City of Boise ADA  
Assessment

# Appendix A-Ivywild Pool House

Report #TO20-B005

**ID:**  
1959

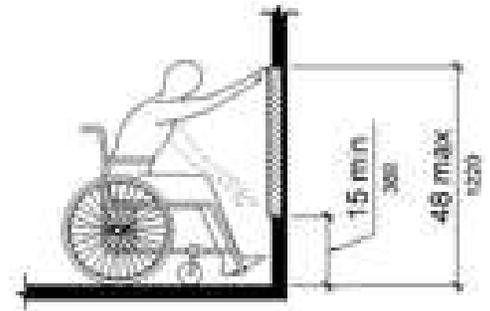
The paper towel dispenser is outside of the unobstructed forward reach range at 61.5" above the floor.

Lower the paper towel dispenser by 13.5" to meet the accessible reach range of 15" minimum and 48" maximum above the floor.

**ID:** 1988      **Facility:** Ivywild Pool House

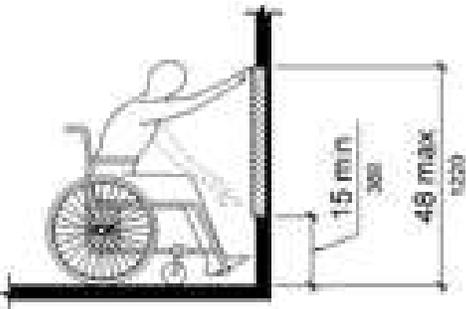
**2010 ADA Standards for Accessible Design Codes: §308.2.1**  
The hooks are outside of the unobstructed forward reach range at 55" above the floor.

Lower the hooks by 7" to meet the accessible reach range of 15" minimum and 48" maximum above the floor.

**ID:** 1934      **Facility:** Ivywild Pool House

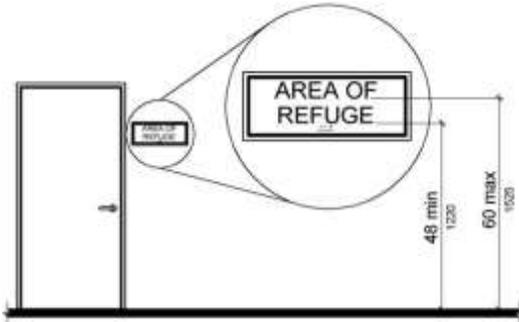
**2010 ADA Standards for Accessible Design Codes:** §216.2, §703  
There is no tactile sign identifying the permanent room.

Install tactile signage on the latch side of the doorway at a height of 48” minimum to 60” maximum above the floor, identifying room by name or room number.  
Signs shall be Braille with raised lettering and should be placed on the wall in the center of an 18"x18" clear floor space.

**ID:** 1935      **Facility:** Ivywild Pool House

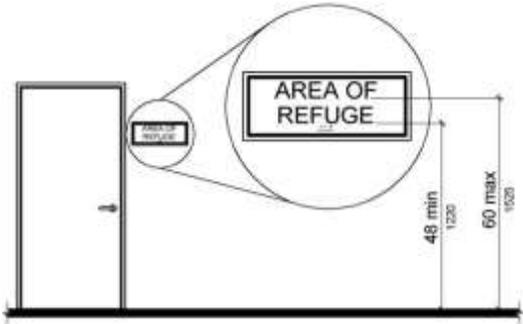
**2010 ADA Standards for Accessible Design Codes: §703.4**  
The tactile signs identifying the rooms are not in the correct locations.

Reinstall the sign on the latch side of the doors at 48" minimum above the floor measured from the baseline of the lowest character and 60" maximum measured from the baseline of the highest character.

**ID:** 1987      **Facility:** Ivywild Pool House

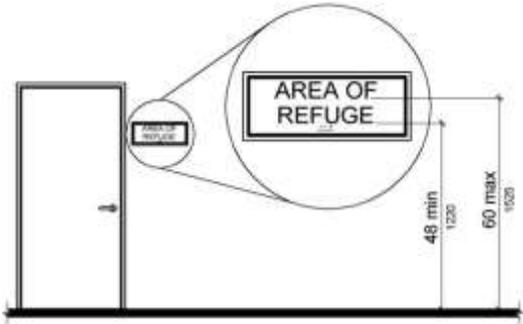
**2010 ADA Standards for Accessible Design Codes: §703.4**  
The tactile sign identifying the room is not in the correct location.

Reinstall the sign on the latch side of the door at 48" minimum above the floor measured from the baseline of the lowest character and 60" maximum measured from the baseline of the highest character.

**ID:** 1980      **Facility:** Ivywild Pool House

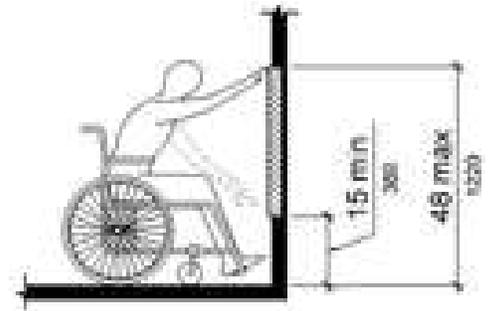
The hooks are outside of the unobstructed forward reach range at 55" above the floor.

Lower the hooks by 7" to meet the accessible reach range of 15" minimum and 48" maximum above the floor.

**ID:** 1972      **Facility:** Ivywild Pool House

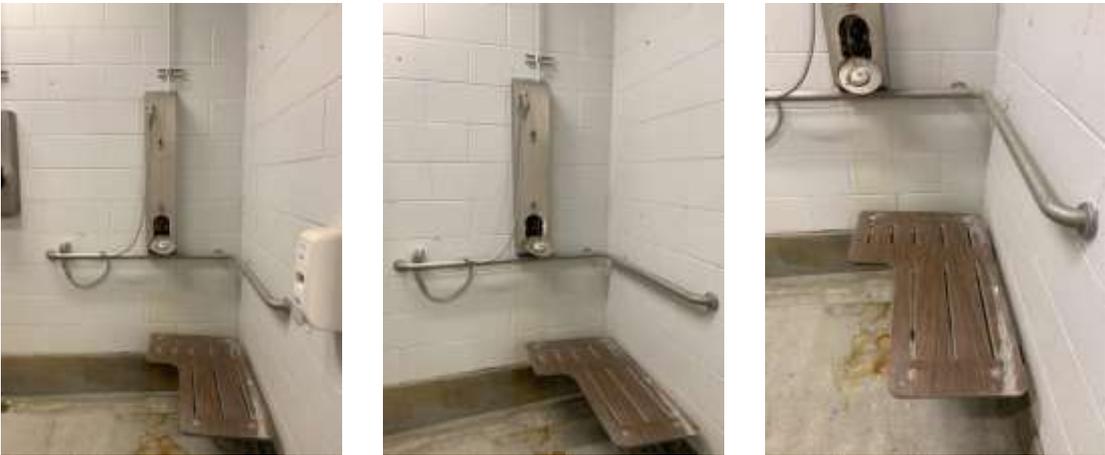
**2010 ADA Standards for Accessible Design Codes: §609.3, §607.6**  
The adjustable shower head bar is missing and the top part of the bar is broken.

Install a new shower head with a 59" long minimum hose to allow for a user to sit or stand.  
Ensure that the shower head is located at least a distance of 12" or greater away from the grab bar.

**ID:** 1976      **Facility:** Ivywild Pool House

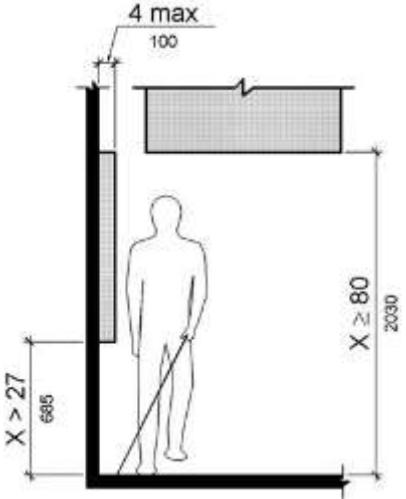
**2010 ADA Standards for Accessible Design Codes: §307.2**  
The soap dispenser protrudes 4.5" into the circulation space at 40" above the floor.

Recess the soap dispenser so it protrudes a maximum of 4", lower it so the bottom edge is 27" maximum above the floor, or place a cane detectable object beneath it.

**ID:** 1985      **Facility:** Ivywild Pool House

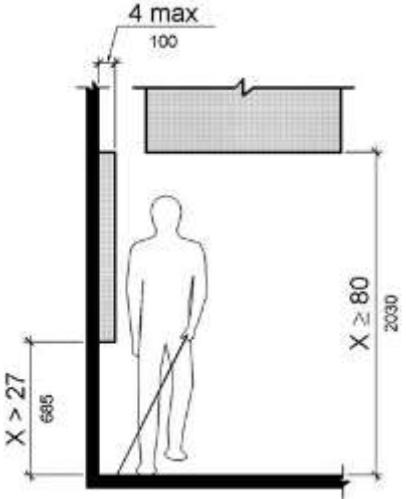
**2010 ADA Standards for Accessible Design Codes: §307.2**  
The hand dryer protrudes 8" into the circulation space at 43.5" above the floor.

Recess the hand dryer so it protrudes a maximum of 4", lower it so the bottom edge is 27" maximum above the floor, or place a cane detectable

**ID:** 1984      **Facility:** Ivywild Pool House

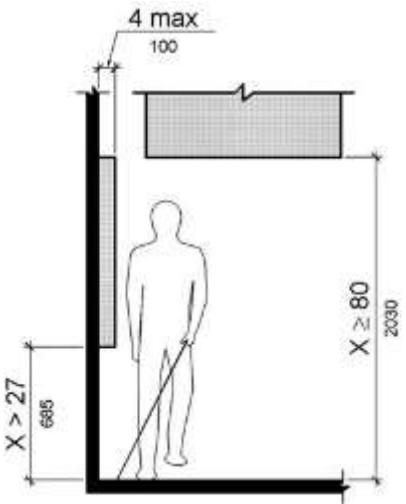
**2010 ADA Standards for Accessible Design Codes: §307.2**  
The paper towel dispensers protrude 8" into the circulation space at 41" above the floor.

Recess the paper towel dispensers so they protrude a maximum of 4", lower them so the bottom edge is 27" maximum above the floor, or place a cane detectable object beneath them.

**ID:** 1977      **Facility:** Ivywild Pool House

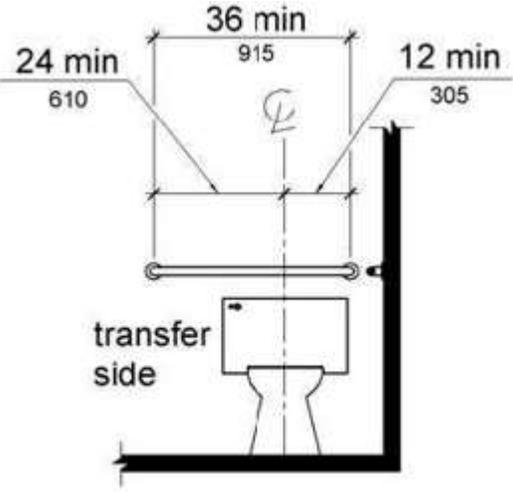
**2010 ADA Standards for Accessible Design Codes: §604.5.2**  
The rear grab bar is located 7" from the side wall.

Replace the rear grab bar with one that is a minimum of 36" long minimum and extends from the centerline of the water closet 12" minimum on one side and 24" minimum on the other.

**ID:** 1979      **Facility:** Ivywild Pool House

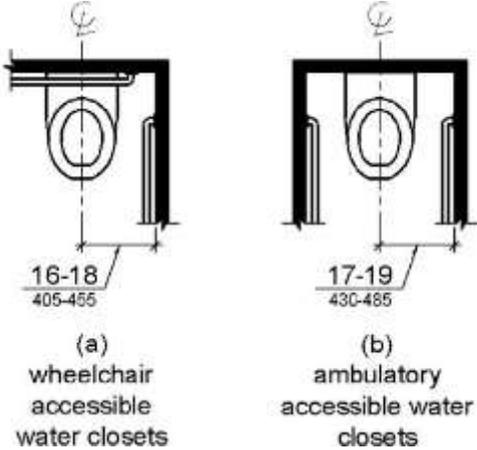
**2010 ADA Standards for Accessible Design Codes: §604.2**  
The toilet is located 19.5" from the sidewall.

Reposition the toilet to be within 16" minimum and 18" maximum from the sidewall.

**ID:** 1969      **Facility:** Ivywild Pool House

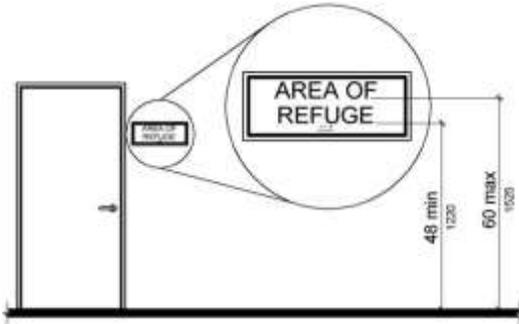
**2010 ADA Standards for Accessible Design Codes: §216.2, §703**  
There are no tactile signs identifying the permanent rooms.

Install tactile signage on the latch side of the doorway at a height of 48” minimum to 60” maximum above the floor, identifying room by name or room number.  
Signs shall be Braille with raised lettering and should be placed on the wall in the center of an 18"x18" clear floor space.

**ID:** 1269      **Facility:** Ivywild Pool House

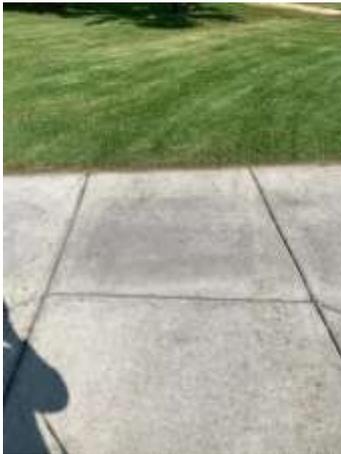
**2010 ADA Standards for Accessible Design Codes: §705**  
The curb ramp does not have a detectable warning.

Install a detectable warning that contrasts visually with the adjacent surface with either light-on-dark, or dark-on-light.

**ID:** 1953      **Facility:** Ivywild Pool House

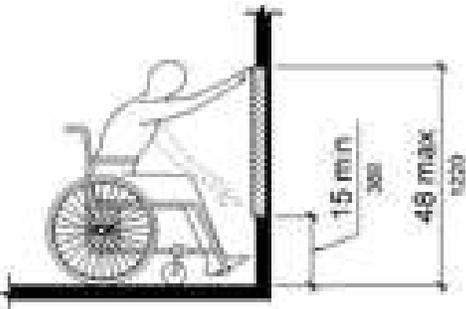
**2010 ADA Standards for Accessible Design Codes: §308.2.1**  
The shower head is outside of the unobstructed forward reach range at 70" above the floor.

Lower the shower head by 22" to meet the accessible reach range of 15" minimum and 48" maximum above the floor.  
Ensure that the shower head is located at least a distance of 12" or greater away from the grab bar.

**ID:**  
1950

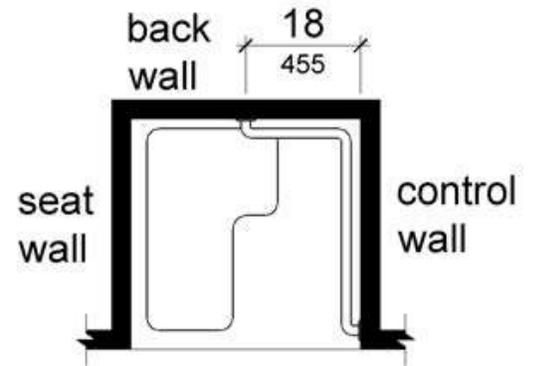
The shower seat is located in the wrong location, under the grab bar.

Install a partition across the control wall and back wall, then relocate the seat to be location on the partition. The partition shall act as a seat wall.

**ID:** 1954      **Facility:** Ivywild Pool House

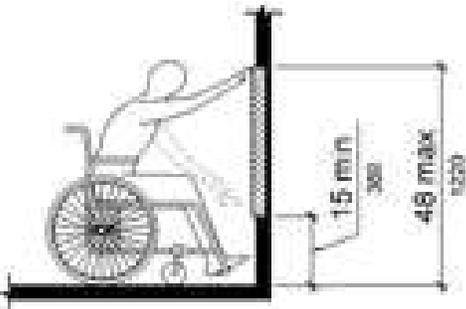
**2010 ADA Standards for Accessible Design Codes: §308.2.1**  
The hooks are outside of the unobstructed forward reach range at 56" above the floor.

Lower the hooks by 8" to meet the accessible reach range of 15" minimum and 48" maximum above the floor.

**ID:** 1940      **Facility:** Ivywild Pool House

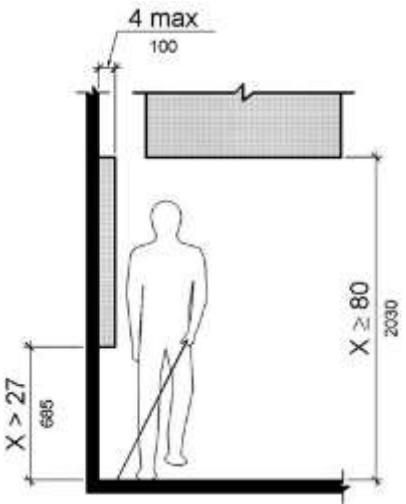
**2010 ADA Standards for Accessible Design Codes: §307.2**  
The paper towel dispensers protrude 8" into the circulation space at 41.25" above the floor.

Recess the paper towel dispensers so they protrudes a maximum of 4", lower them so the bottom edge is 27" maximum above the floor, or place a cane detectable object beneath them.

**ID:** 1939      **Facility:** Ivywild Pool House

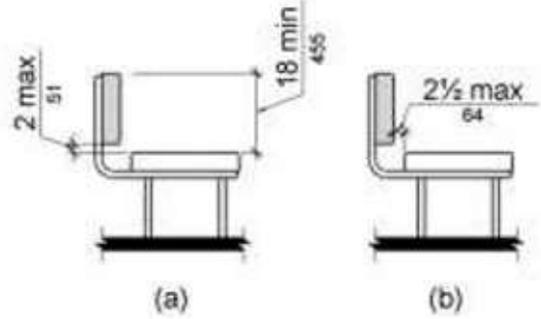
**2010 ADA Standards for Accessible Design Codes: §903.3**  
There benches the women's locker room are 12" deep.

Install one new bench that is at least 42" long and 20" to 24" inches deep. The accessible bench shall have a back support or be affixed to a wall.

**ID:** 4465      **Facility:** Ivywild Pool House

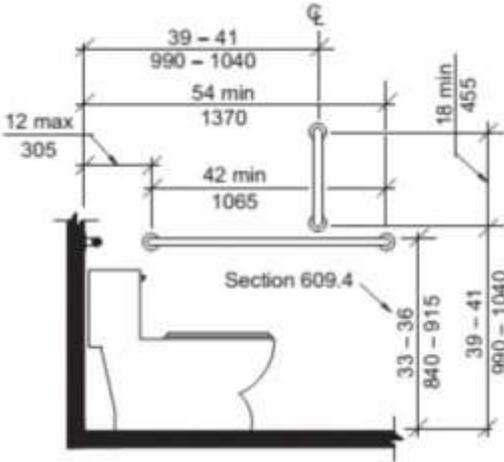
**2010 ADA Standards for Accessible Design Codes: §604.7**  
The toilet paper dispenser is not located in an accessible position at 12" in front of the toilet.

Remount the toilet paper dispenser so that the centerline is located 7" minimum to 9" maximum in front of the toilet.

**ID:** 1947      **Facility:** Ivywild Pool House

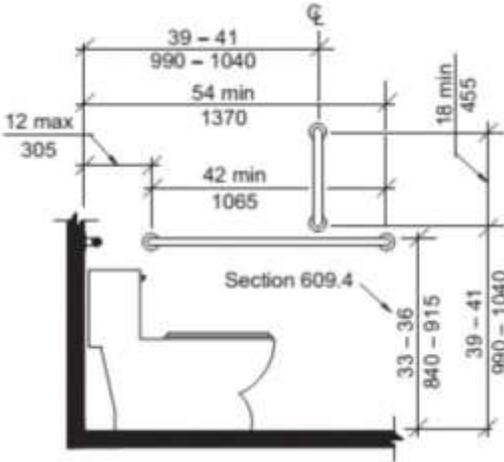
**2010 ADA Standards for Accessible Design Codes: ICC A117.1 §604.5.1**  
The accessible water closet does not have a vertical grab bar.

Install an 18" long (minimum) vertical grab bar, mounted with the bottom located at 39" minimum and 41" maximum above the floor.  
The centerline of the vertical grab bar shall be located 39" minimum and 41" maximum from the rear wall.
